CORNER LOT HOUSE (APN 210)

San Mateo County Board of Supervisors' Meeting

File Numbers: **PLN 1999-00015**

SUBJECT: Consideration of a Coastside Design Review Permit, pursuant to Sections 6565.4 (Coastal) and 6328.5 of the County Zoning Regulations as they existed in 1999, to construct a new 2,548 sq. ft. single-family residence on a 5,000 sq. ft. parcel located at 286 Second Street, in the unincorporated Montara area of the County. (Appeal from decision of the Planning Commission denying the Design Review Permit.) This project is not appealable to the California Coastal Commission.

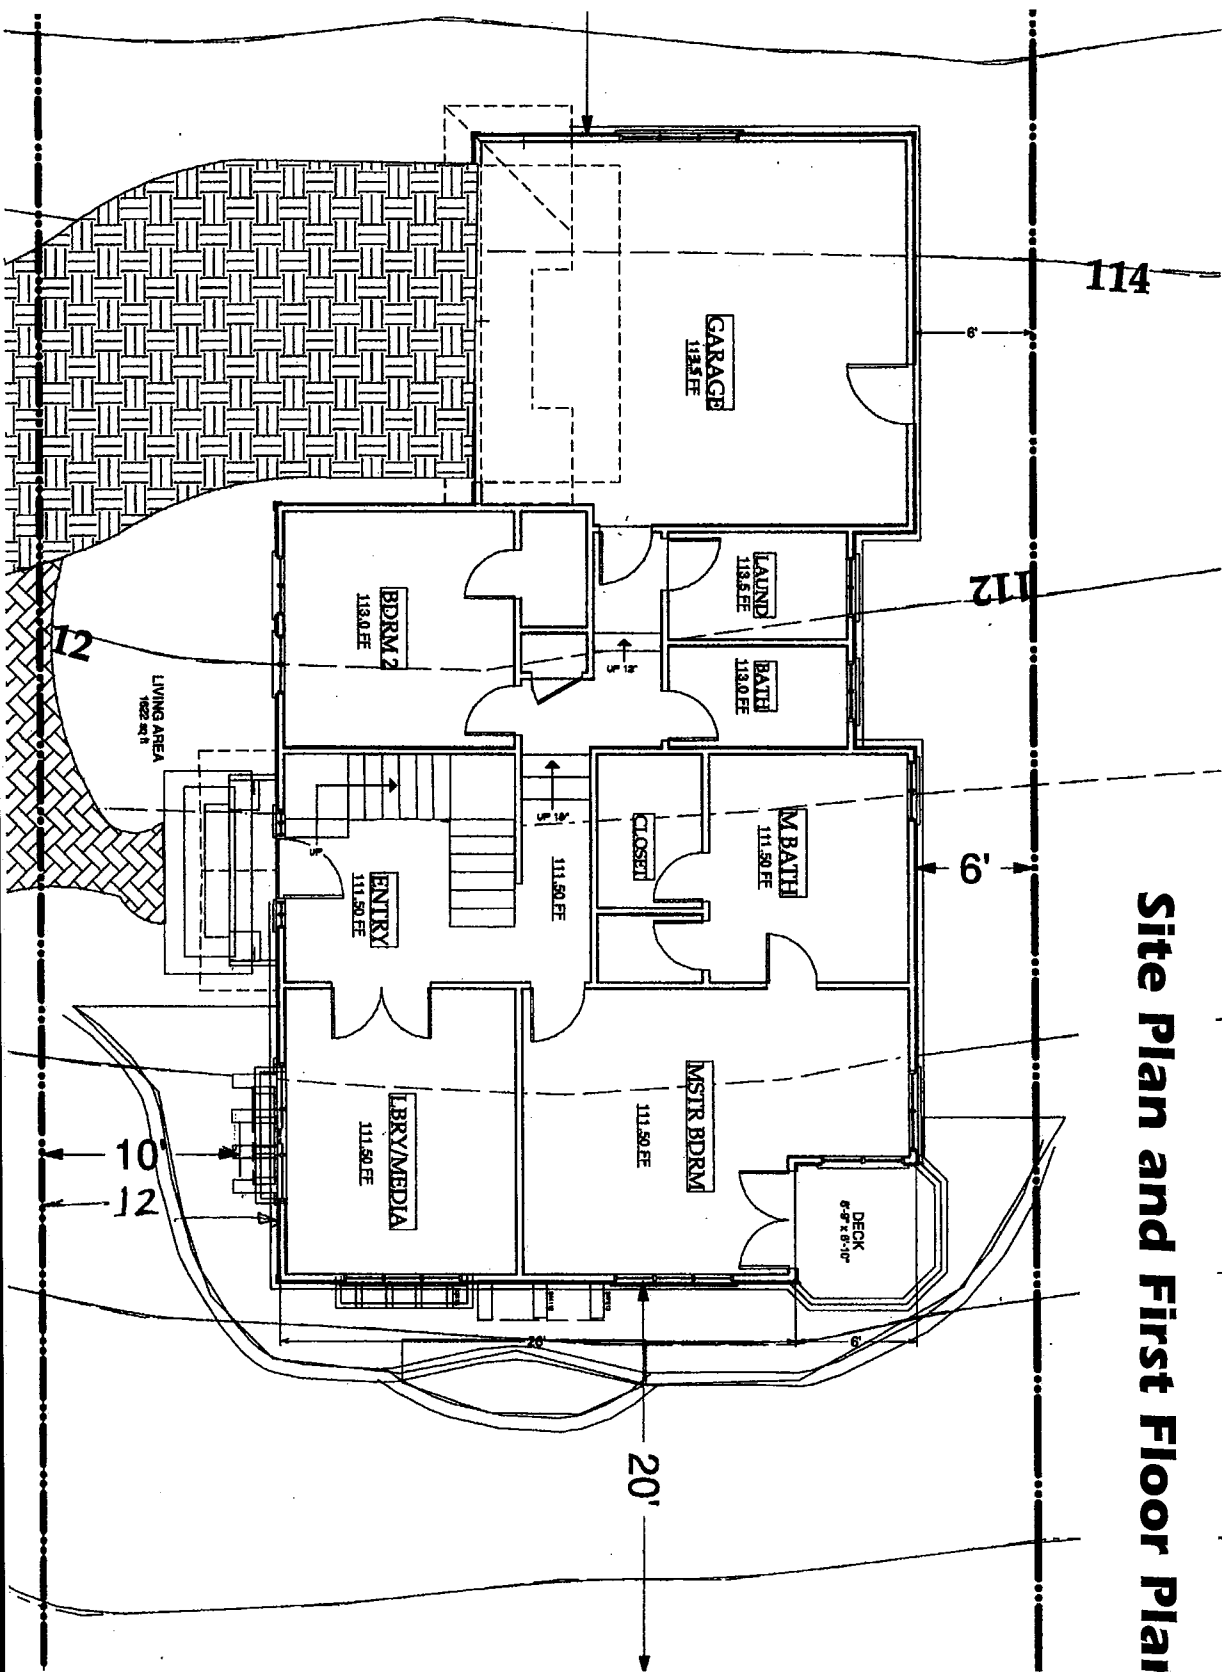
Modifications to plans made pursuant to directives from San Mateo County Board of Supervisors at hearing held on 3/31/09 :

- 1.) Building Lowered into the Ground
- 2.) Design Form more closely mimicking the natural terrain of the site with both roof-line as well as floor-line.

- 3.) Reduction of Building Mass *via* :
 - a.) Complete Hip-forming of entire Roof structure.
 - b.) 50% increase in set-back of upper-story above Garage – a location directly visible from street.

- c.) House Plans now contain three (3) separate levels – following the rise in terrain.
 - d.) Diminution of Entry Element – scale has been reduced in size in relation to building.

- e.) Elimination of lower story projection on long street-side elevation – reducing mass from prominent street-side elevation.
 - f.) Reduction in building length – rear setback increased to 22 feet.

- g.) Lowering plate-height of prominent second story area directly above entry – breaking up both façade mass as well as lowering roof-line on a significant section of the prominent street-side elevation.

- h.) 50% differential in 'cut-in' area at front corner & side elevations between upper & lower floors – upper floor now containing less mass than lower floor in this prominent street-side elevation.

- 4.) Softened aesthetics to street on both sides *via* :
 - a.) Introduction of corbelling under window-seat at front elevation, and at upper story projection on long street-side elevation – creating additional detail & visual interest, breaking up linear aesthetic, and further emphasizing traditional design theme of building.

- b.) Introduction of traditional type large 'beadboard' style trim above windows, and traditional type 'stool' style trim below window trim – creating additional detail & visual interest, reducing linear aesthetic, as well as further emphasizing traditional design theme of building.

- c.) Introduction of lower-story window planter-boxes – creating additional detail & visual interest, as well as further emphasizing traditional design theme of building.

- d.) Introduction of landscaped raised stone planter beds at front and corner sides of building – reducing apparent building height from front street elevation and softening building plane into ground plane.

- e.) Employment of curving driveway to soften direct approach to street from building as well as to utilize existing driveway culvert at street elevation.

Site Plan and First Floor Plan

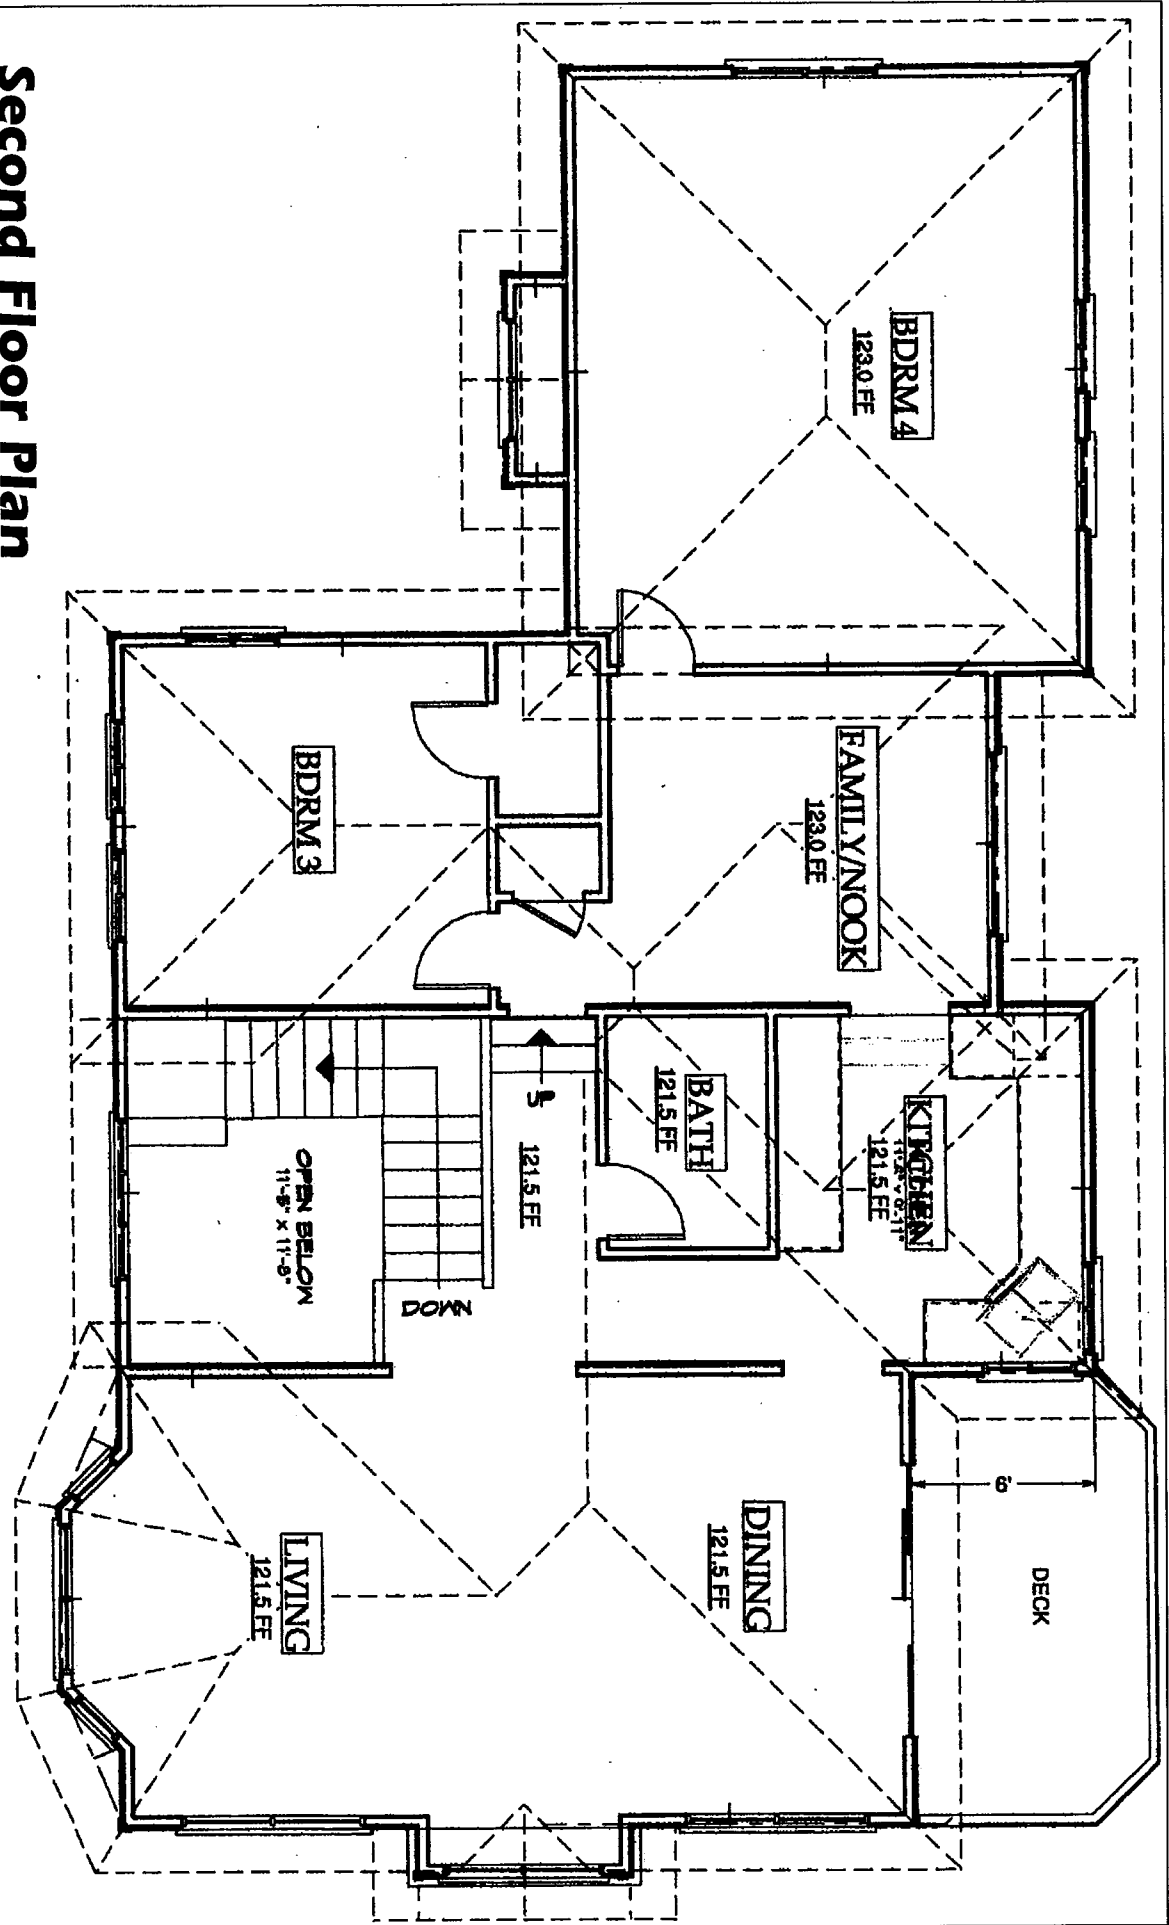
The plans have consistently omitted any description of existing vegetation on the site. The revised plans do show one significant pine tree, which is to remain on the site. However, no other vegetation has been identified either as existing or proposed for removal. The Design Review standards call for all existing trees

and their sizes to be marked on the site plan. In addition, the requirements call for the trees proposed for removal to be marked and for all site improvements to be notated on the site plan.

9. The submitted plans do not indicate any trees to be removed. Prior to the issuance of a building permit, the applicant shall submit a plan showing the location of all existing trees on the property. The applicant shall submit a tree protection plan for the tree located towards the rear of the parcel, near Farallone Avenue. Such measures shall be identified on the building permit site plan and shall be implemented prior to the start of any construction or grading activities on the site. Removal of any additional trees with a diameter equal to or greater than 12 inches as measured 4.5 feet above the ground shall require a separate tree removal permit.
